Project Address: 4323 East Towne Boulevard
Application Type: Conditional Use
Legistar File ID # [30658](#) and [29803](#)
Prepared By: Kevin Firchow, AICP, Planning Division
Report Includes Comments from other City Agencies, as noted

Requested Action: The applicant requests conditional use approval to amend the existing Planned Multi-Use Site and to allow outdoor seating.

Proposal Summary: The applicant proposes to construct a 7,864 square foot restaurant on a lot along the East Towne frontage road which is now utilized for surface parking. As part of this proposal, the applicant also requests approval to have outdoor dining.

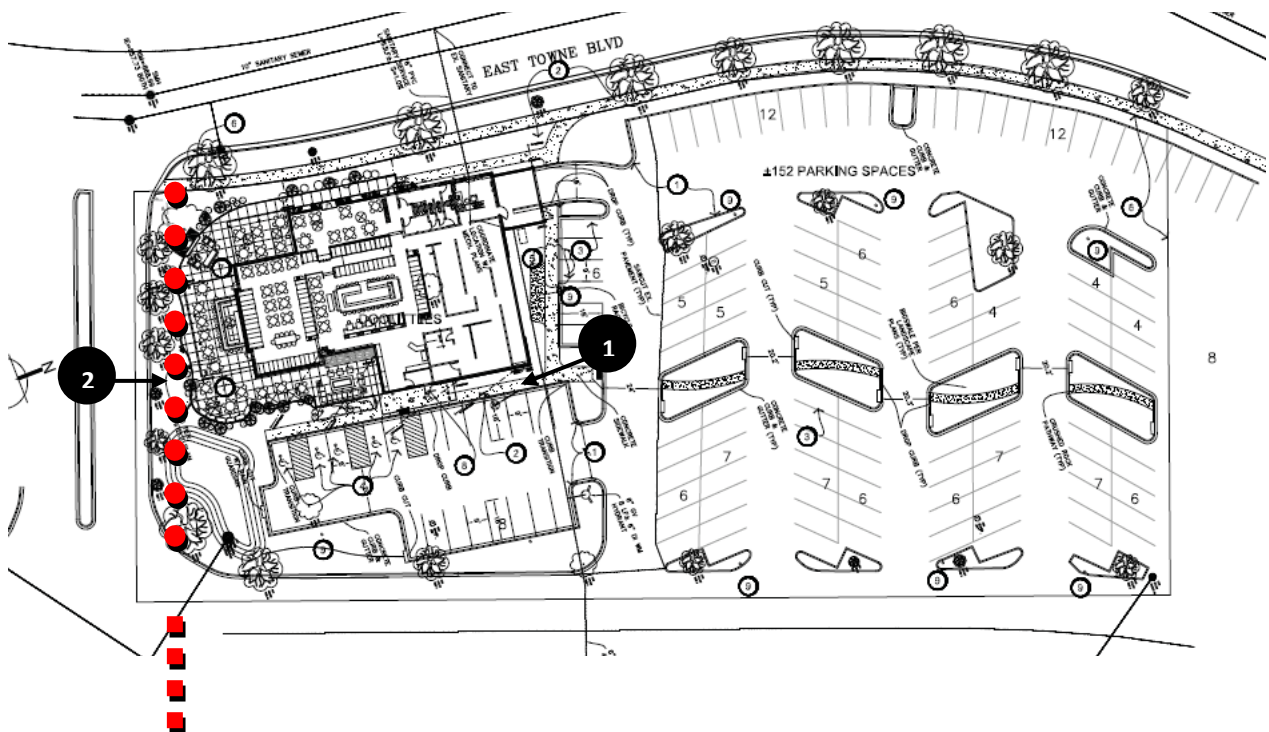
Standard 5 states that "Adequate utilities, access roads, drainage, parking supply, internal circulation improvements, including but not limited to vehicular, pedestrian, bicycle, public transit and other necessary site improvements have been or are being provided." In regards to that standard, staff recommends the following pedestrian-related improvements, noting that the site sits directly across from a recently installed bus stop on the private inner ring-road. The general location of these recommendations are noted on the below graphic.

1. Widen the private sidewalk leading from the parking lot to the main door from five (5) to six (6) feet. Currently, there is nine feet between the building and the parking stalls. This would result in the associated landscape area being reduced in size by roughly one foot.
2. Install a five (5) foot wide sidewalk adjacent to existing trees along the mall ring-road. (Between the existing trees and the proposed patio area). Minimally, staff recommends that a sidewalk be extended from East Towne Boulevard to East Towne Way (private street). A cross walk should be added to connect to the sidewalk on the opposite side of East Towne Way.
3. Provide a direct pedestrian route connecting the main building entrance to the bus stop on the opposite side of East Towne Way.

1. That the proposed 5 foot sidewalk along the front (east) side of the building, connecting the parking lot to the main building entrance be widened to 6 feet. Details shall be approved by the Planning Division and Traffic Engineering Division.

2. That the applicant installs a five (5) foot wide sidewalk adjacent to existing trees along the mall ring-road on the west side of the property. (Between the existing trees and patio area). Details shall be approved by the Planning Division and Traffic Engineering Division.

3. That a direct pedestrian route connecting the main building entrance to the bus stop on the opposite side of East Towne Way. Details shall be approved by the Planning Division and Traffic Engineering Division.
